# CITY PLANNING DEPARTMENT

## Memorandum – Unified Development Review

**To:** City Plan Commission  
**From:** Brianna Valcourt, M.Arch | Senior Planner  
**Date:** May 22, 2024  
**RE:** Itri Commons: 1455 Park Avenue – Assessors Plat 11-2, Lots 269, 2822, & 2823  
**Application for Dimensional Variance**

**SITE PLAN**

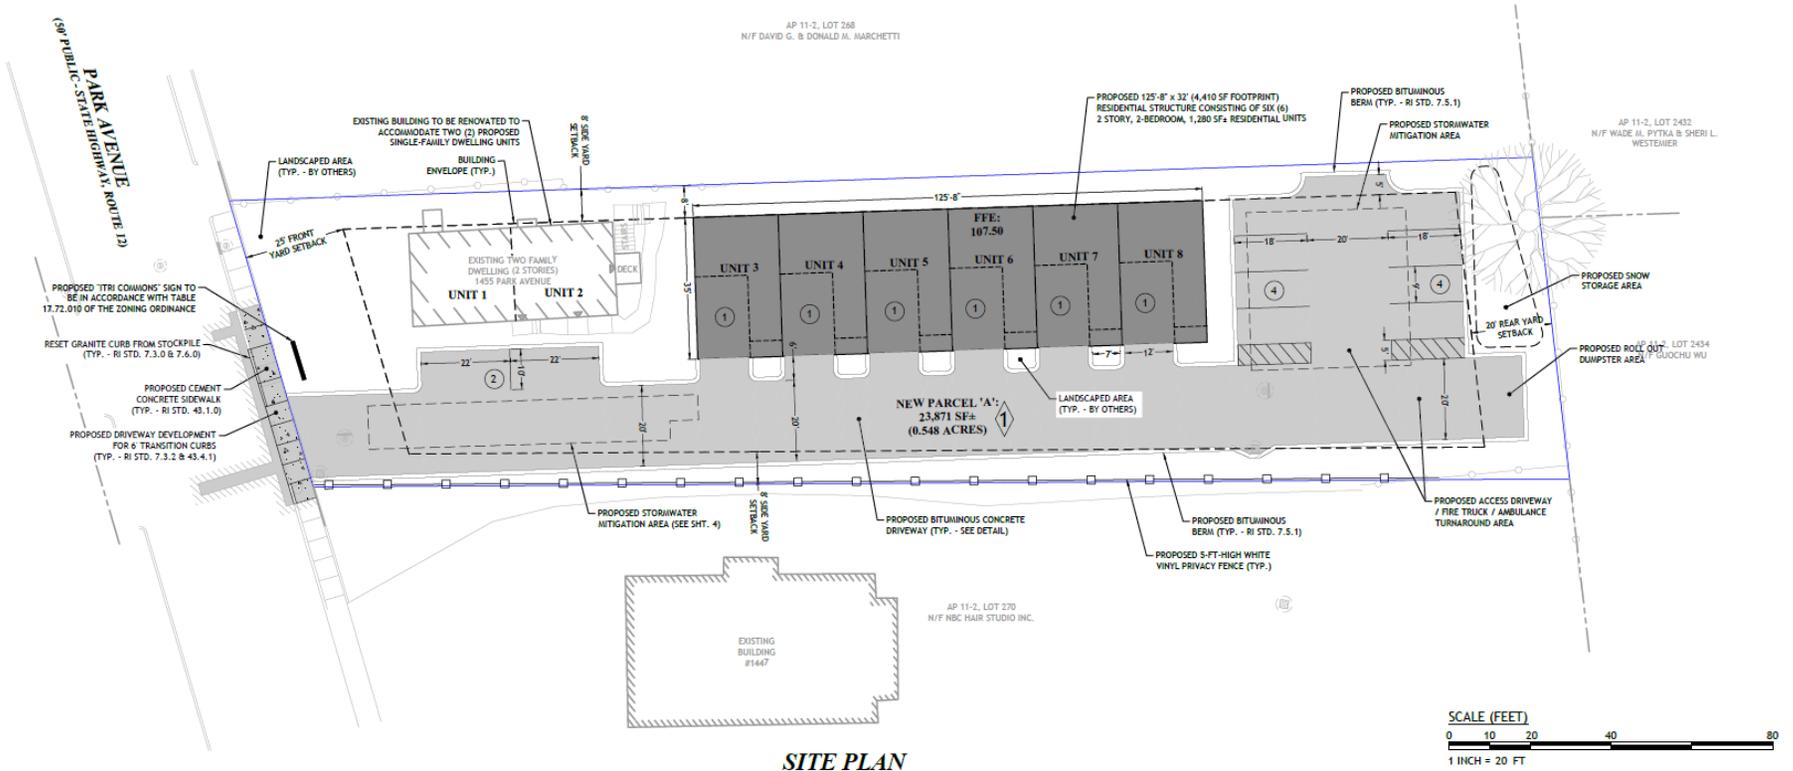
3. Fire Department: Mr. James Woyciechowski, Fire Marshal, has provided concerns regarding the Fire department access, which is limited at this time. An additional concern is resident/visitor parking along the eastern side of the driveway, although no parking spaces are proposed in this area, he recommends no parking and that the space be reserved for fire access only.
